RE: Second Round Referral Comments for SPEX 2007-0021

This letter constitutes the Applicant's response to staff and agency second submission review comments regarding the above-referenced application. Each staff and agency comment is noted in italics, followed by the Applicant's response.

Loudoun County Department of Zoning Administration (comments dated March 12, 2010)

TRAFFIC PHASING & PEDESTRIAN CIRCULATION PLAN

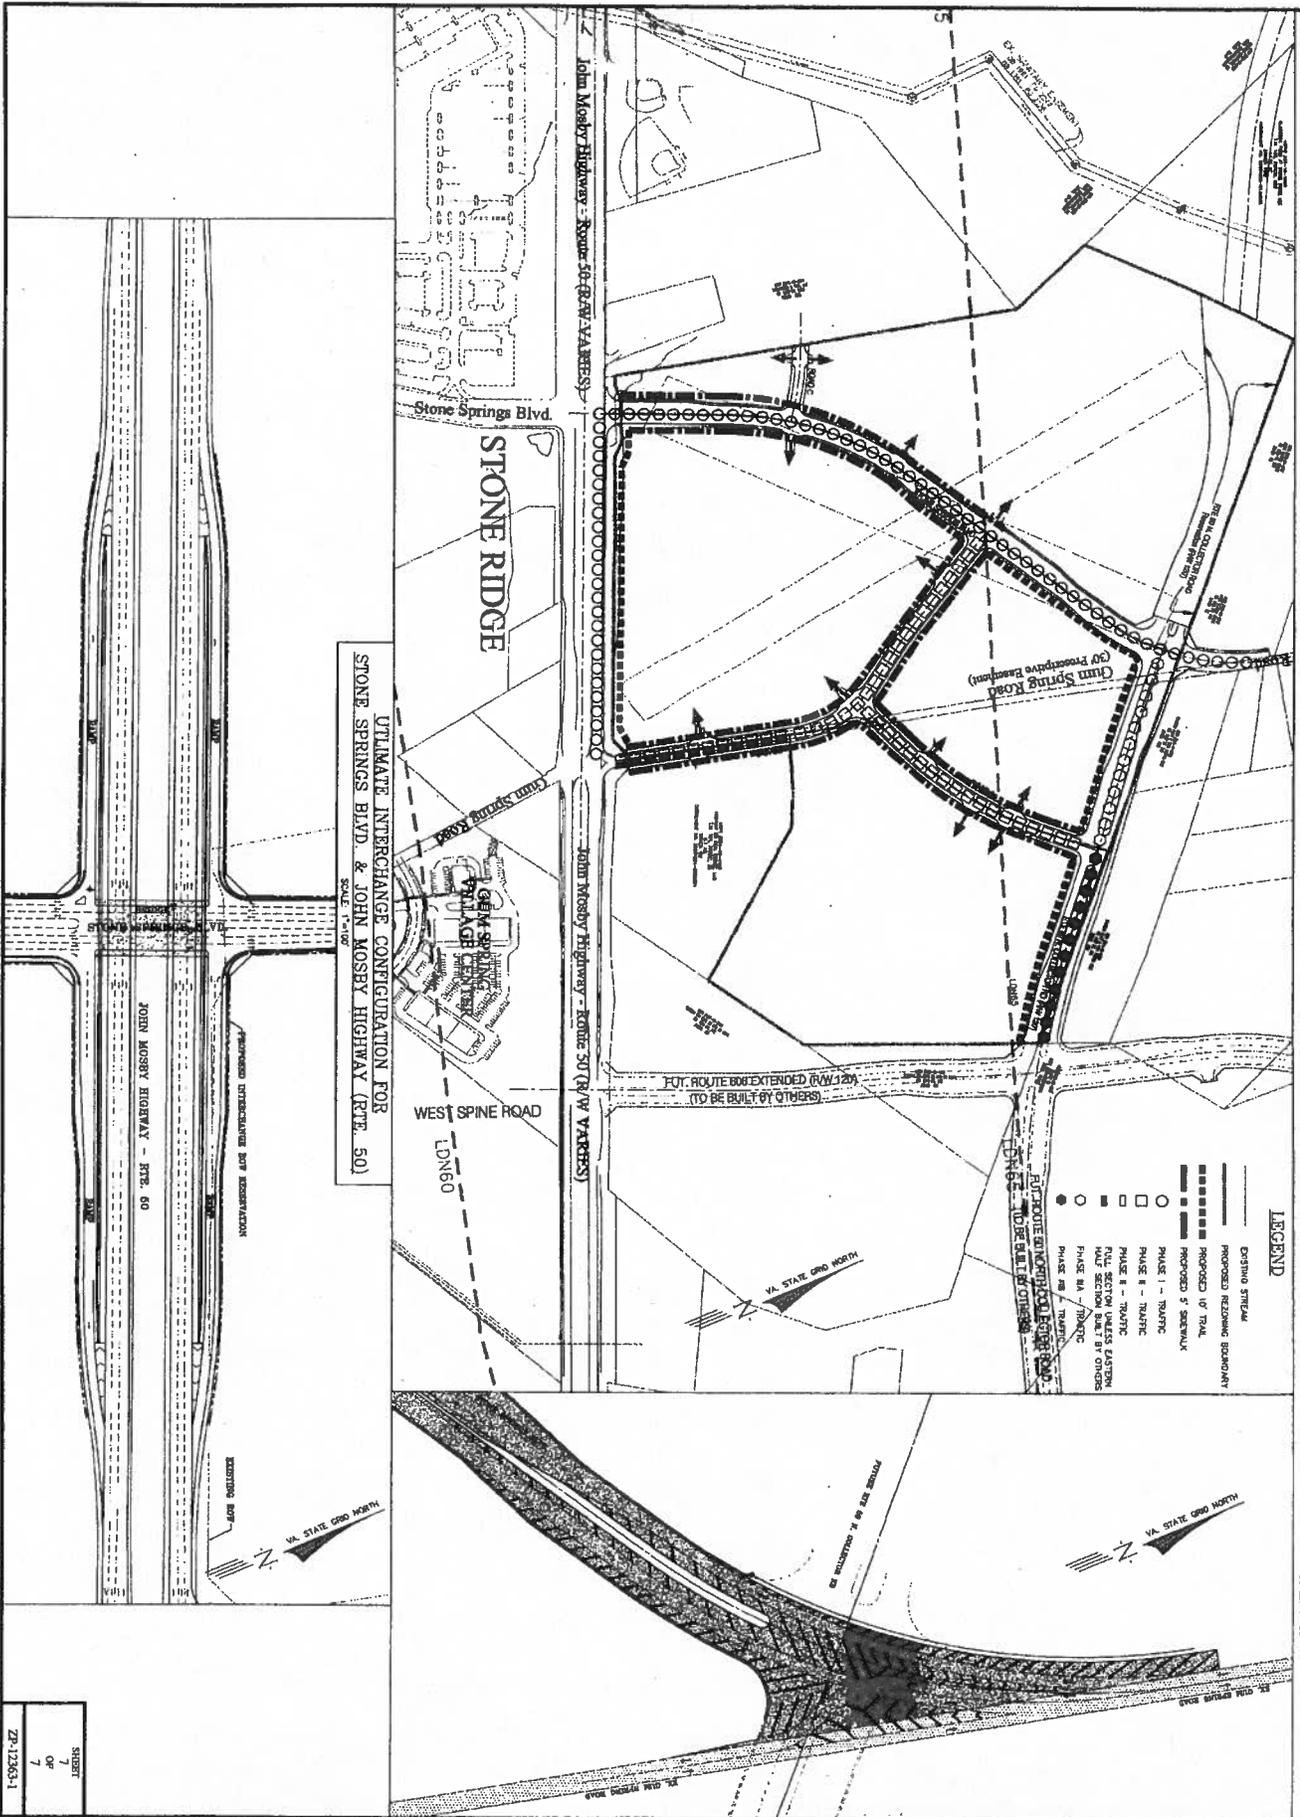
4. Sheet 7 – *Traffic Phasing & Pedestrian Circulation Plan* – *If the applicant wishes to include this sheet in the plan set, remove the "For illustrative purposes only" as this is a proffered sheet per ZMAP-2006-0007. As the property is subject to the proffers and CDP of ZMAP-2006-0007, this sheet is not for illustrative purposes.*

Response: The note "For illustrative purposes only" has been removed from Sheet 7.
